Access Compliance Report

Public Rights-of-Way

(Curb Ramps)

Intersection ID: N/A	Main Street: SOUTH_STREAM_BV	Cross Street: N/A	Location: SW
ADA ID: 84530CE0197D	Ramp Type: PerpDiag	Initial Pass/Fail: Fail	Overall Compliance: No
Codes/Mitigation Info/Possible Solution		Field Measurements/Component Compliance

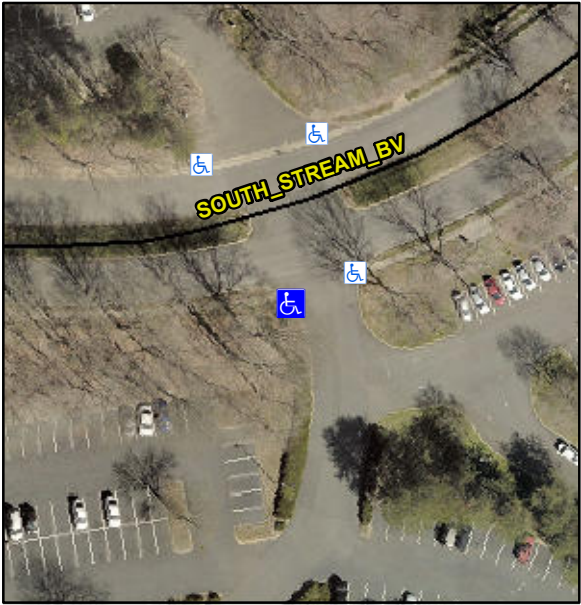
Possible Solutions:	Compliance	Description	Data	Compliance	Description	Data
	Remove & Replace Curb Ramp With Two New Directional Ramps or Equivalent.	N/A	Ramp Length (in)	60.0	No	Ramp Slope (%)	14.8
<p>Surveyor Notes:</p> <p>N/A</p> <p>PROW/ADA:</p> <p>Not Found, R304.5.1, R304.2.2, R304.5.3</p>		No	Ramp Width (in)	45.0	No	Ramp XSlope (%)	5.3
		N/A	Flare Type LT	N/A	N/A	Flare Type RT	N/A
		N/A	Flare Slope LT (%)	N/A	N/A	Flare Slope RT (%)	N/A
		N/A	Flare Traversable LT?	No	N/A	Flare Traversable RT?	No
		N/A	Landing Length (in)	N/A	N/A	DWS Provided?	N/A
		N/A	Landing Width (in)	N/A	N/A	DWS Contrast?	N/A
		N/A	Landing Slope (%)	N/A	N/A	DWS Length (in)	N/A
		N/A	Landing X Slope (%)	N/A	N/A	DWS Full Width?	N/A
		N/A	Landing Curb? (Y/N)	N/A	N/A	DWS Offset (in)	N/A
		N/A	Shared Landing?	N/A			
		N/A	Gutter Ponding?	N/A	N/A	Gutter Slope (%)	N/A
		N/A	Gutter Lip Ht (in)	N/A	N/A	Gutter X Slope (%)	N/A
		N/A	Painted X Walk1?	No	N/A	Painted X Walk2?	No
